Airworthiness Directive

Amendment 39-3810; AD 80-14-03

Airworthiness Directives; Piper Model PA-28-161, PA-28-181, PA-28-201T, PA-28-236, PA-28R-201, PA-28RT-201, PA-28R-201T, PA-28RT-201T, PA-32-260, PA-32-300, PA-32-301, PA-32-301T, PA-32R-300, PA-32RT-300, PA-32RT-300T, PA-32R-301, PA-32R-301T, PA-34-200T and PA-44-180 Airplanes

FIGURE 1.
AD NO. 80-14-03

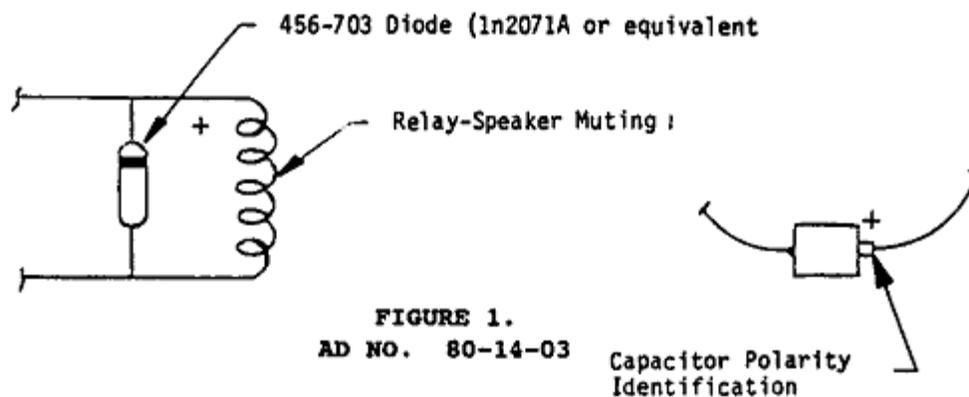
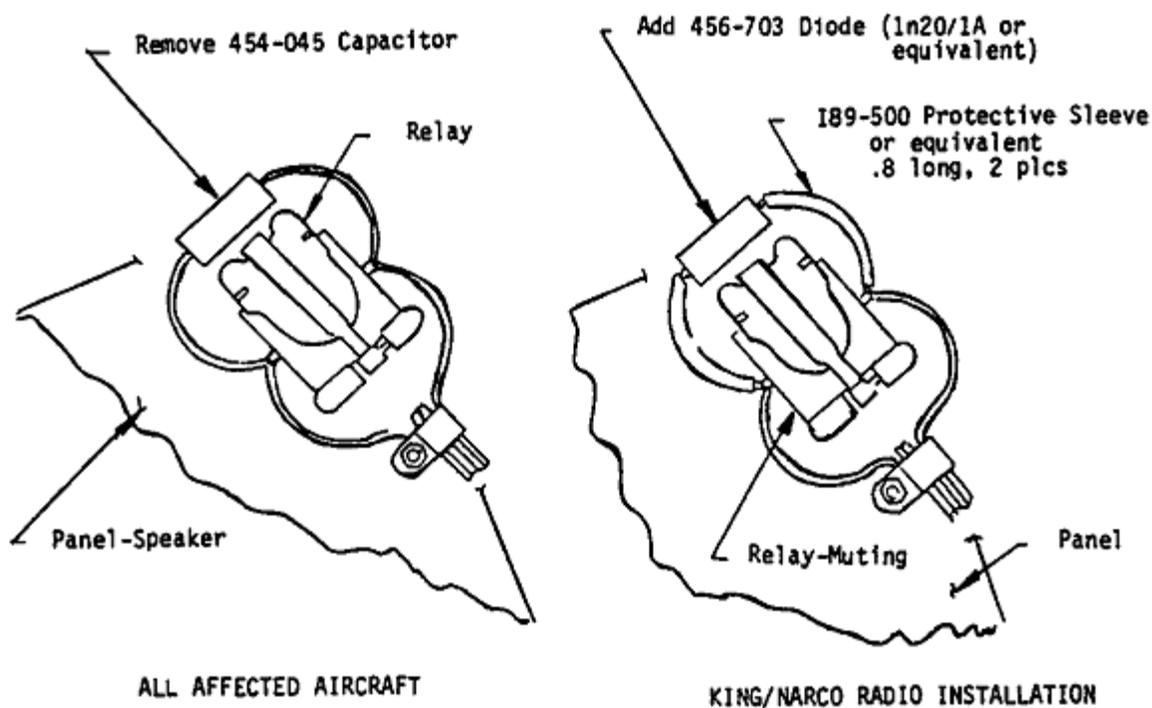
(2) Remove the 22 mfd capacitor, part number 454-045, soldered to the muting relay, noting polarity, and install diode as shown in figure 1. Diode is not required on Bendix avionics systems.
